**ADDENDUM NO. 2**  
**13 September 2013**

TOWN OF ACTON  
GENERATOR UPGRADE AT DISTRICT ONE & TWO FIRE STATIONS  
Acton, Massachusetts

TOWN OF ACTON  
472 Main Street  
Acton, MA 01720  
978-929-7744

Reference Contract Documents (drawings and specifications) dated 29 August 2013.

**SKE-4**

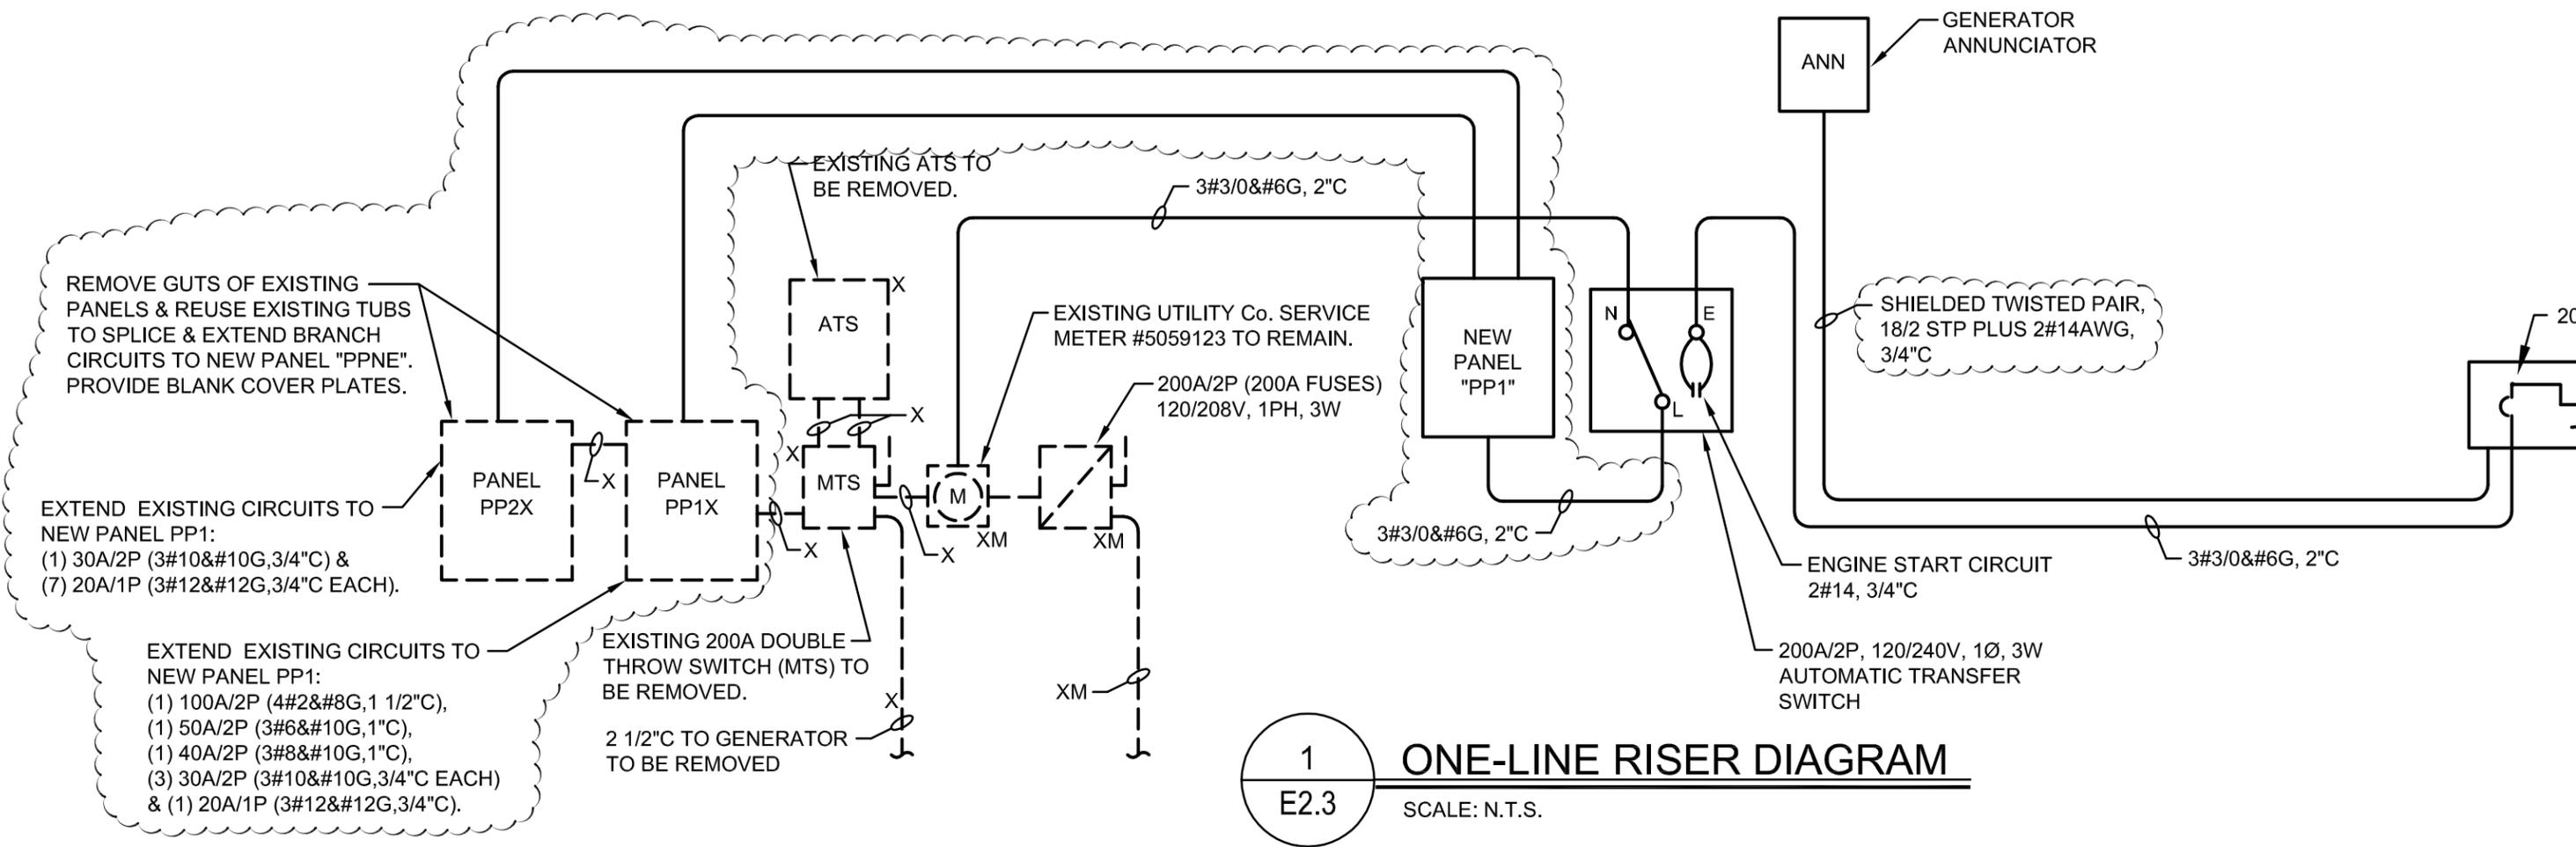
Item 6. E2.2 - ELECTRICAL FLOOR PLAN & SITE DETAILS

- Detail 1 shall be labeled 1/E2.2, in lieu of 1/E1.0 indicated.
- Detail 2 shall be labeled 2/E2.2, in lieu of 2/E1.0 indicated.
- The (2) existing panel boards ("PP1" & "PP2") shall be tagged "X" (to be removed), see riser.
- Conduit for annunciator panel feed shall be changed to 3/4"C, in lieu of 1"C.
- Incorporate the clarifications and/or revisions on the following sketch: SKE-4.
